REQUEST FOR INFORMATION #05

Date:	5/12/2021	Contractor:	Exbon Development Inc.
Contract Number:	58855	Project Title:	LIB Room 202 Grad Studies Renovation
Specification Page No.:	N/A	Plan Sheet No.:	A-2.01
Signature:	Chaitanya Thalati

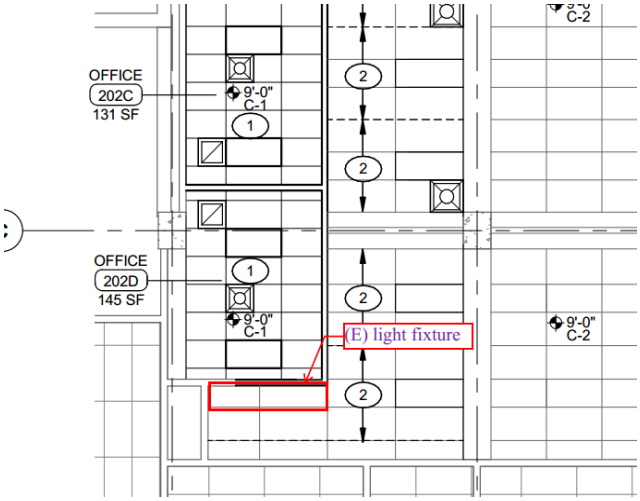
(E) light fixture is in the way of (N) wall in Office 202D area. Please see attached.

During the on-site visit (5/11/2021) David Mathison advised to move the lights to construct the wall per the plan. Please confirm and provide the new location for light fixtures. Also, advise if (E) light fixture or (N) light fixture to be installed in new location.

Relocate existing light fixtures to noted area on Page 2. Existing register and duct is within the scope of work to be removed.
